Request of Class II Permissive Change

Company name Sun Cupid Technology (HK) Ltd.
FCC ID: 2ADINS6003L
FCC Part 15 Certification

CPU:

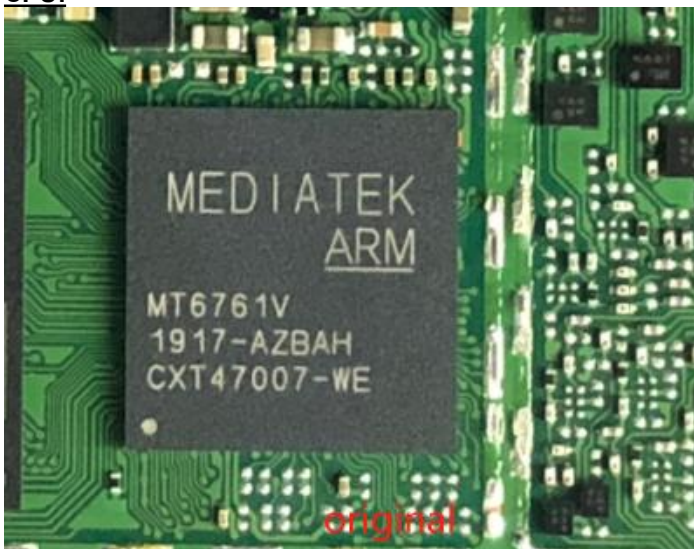
Change 1: **Change the Chipset from MT6761V/WE to MT8766V/WBA(Pin to Pin replacement CPU).
So need to retest EMC,2.4GWIFI BLE BT retest Radiated Emissions in Non-restricted
Frequency Bands,GSM WCDMA LTE retest spot test Field Strength of Spurious
Radiation,5GWIFI retest Unwanted Emissions**

**The RF parameters have not changed, and the antenna and antenna position have not
changed**
